The Town of Hilton Head Island Regular Design Review Board Meeting

UPDATED AGENDA

The Town of Hilton Head Island
Design Review Board
Minutes of the Tuesday, August 23, 2011 Meeting **DRAFT**
1:15pm – Benjamin M. Racusin Council Chambers

TOWER ELEVATION
NT5

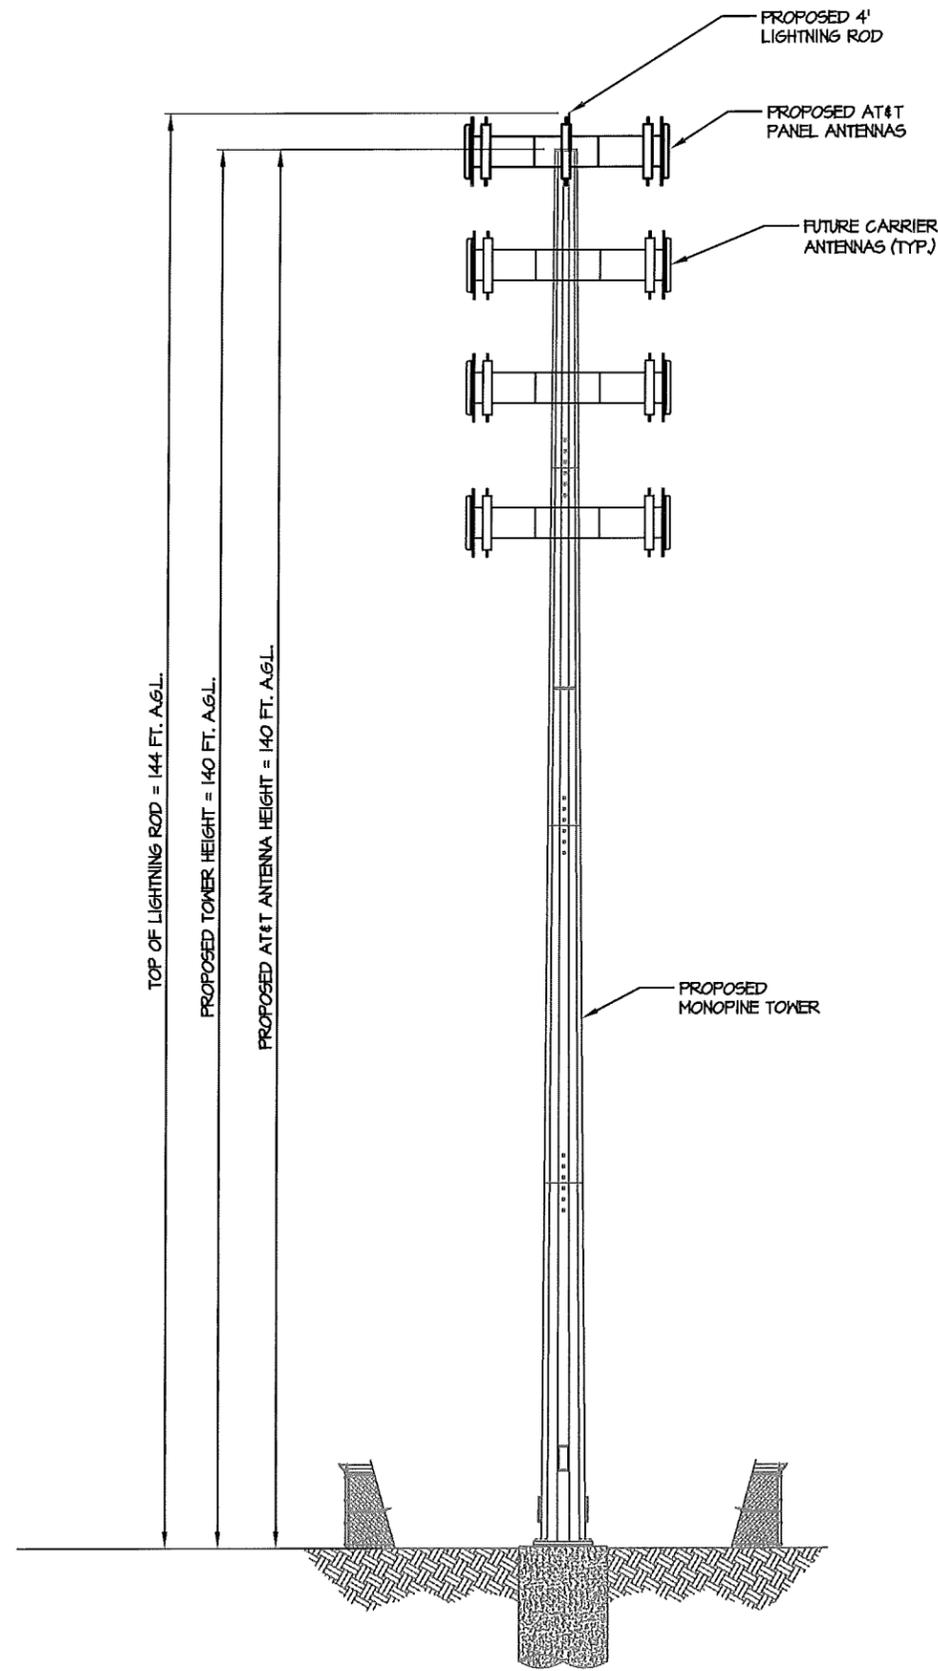
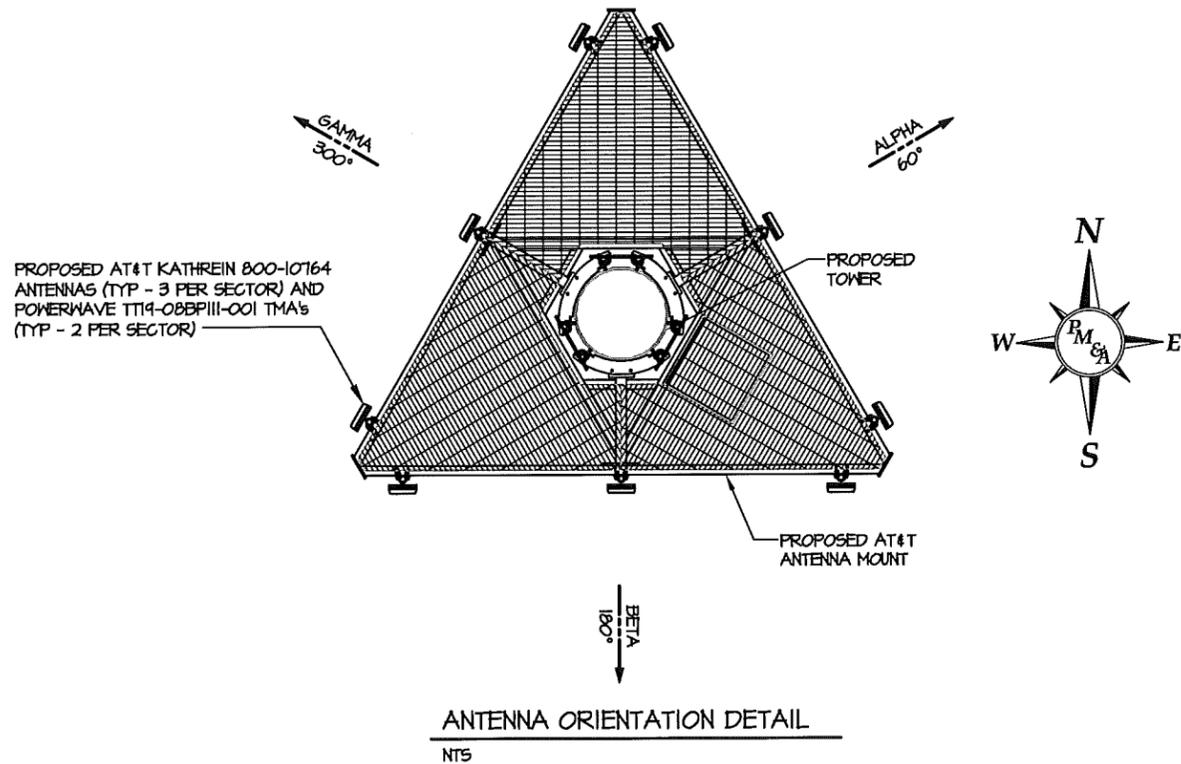
The applicant wishes to resubmit the previously approved tower project, eliminating the false tree elements as camouflage. This will now be a standard looking tower, similar examples of which can be found elsewhere on the island. The tower is below the height requirements for any strobe lighting.

Sheet Title:
 FRONT ELEVATION

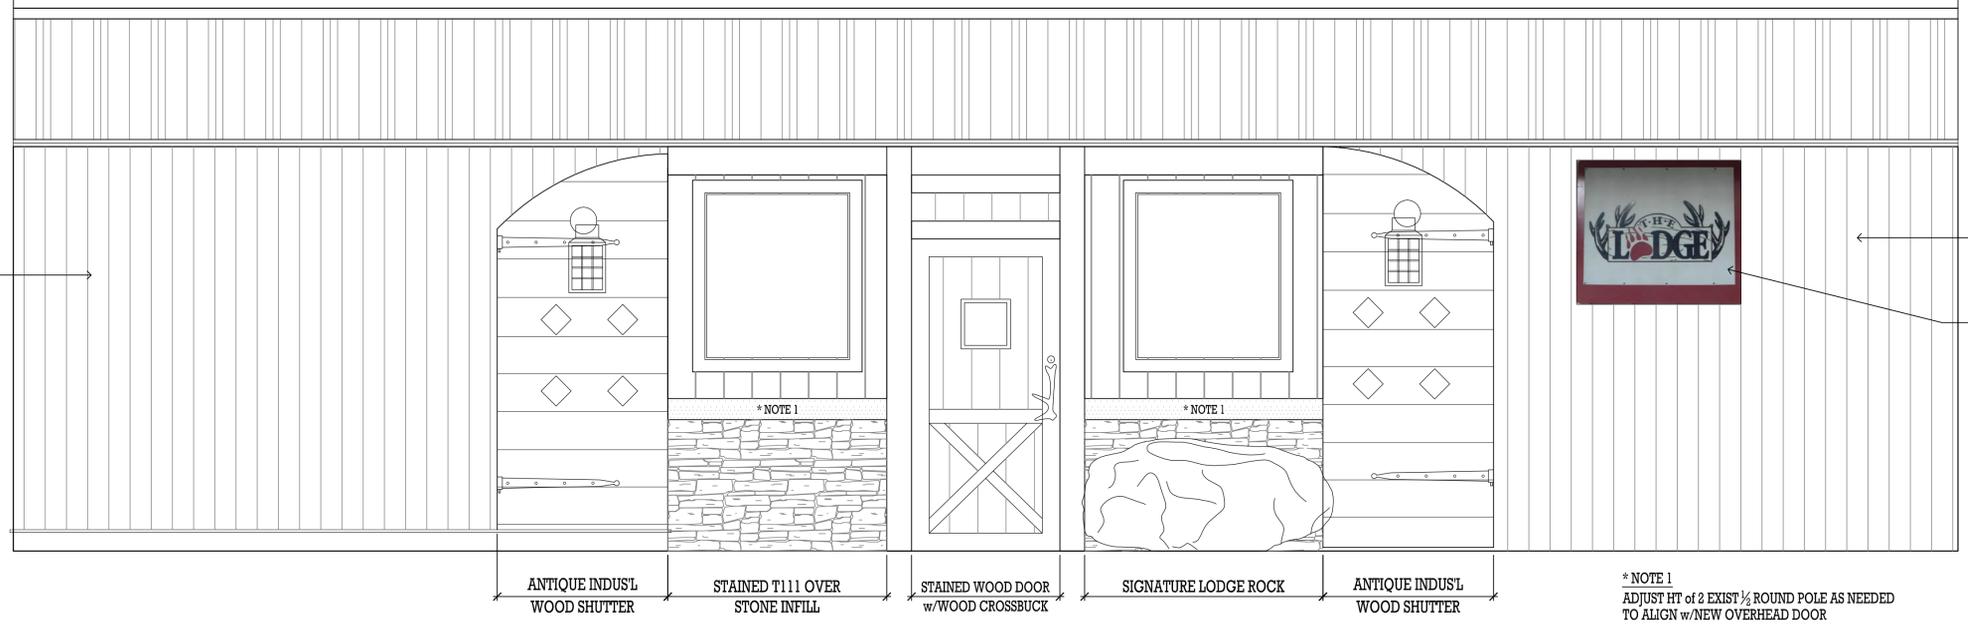
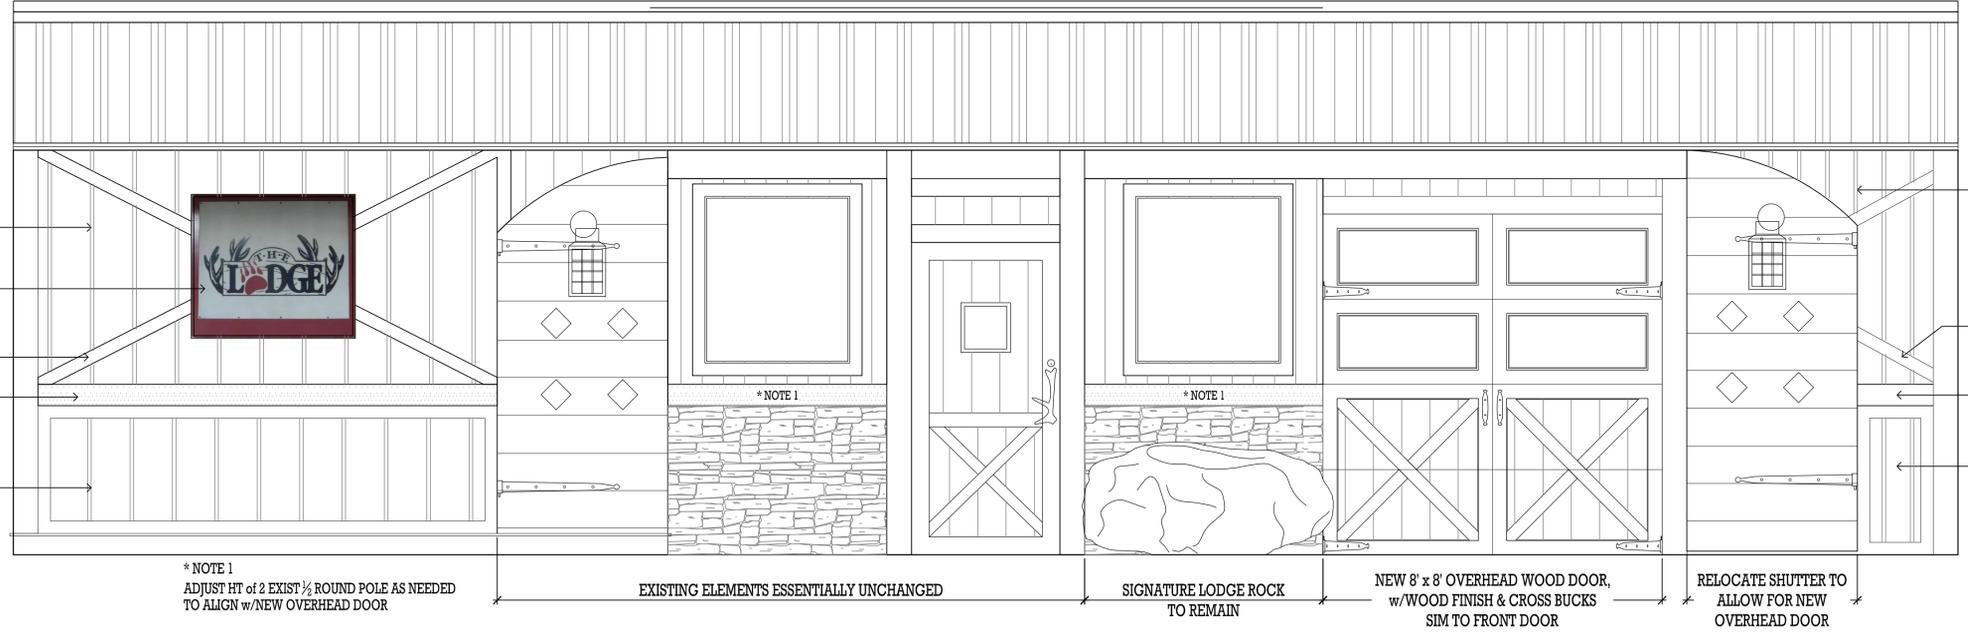
The applicant has reworked the storefront to incorporate board and batten siding, and honor the existing details and trim work in the door as a unifying element. Consolidating the finishes by staining everything to match existing goes a long way to meeting the Board’s request to tie together the proposed storefront modifications.
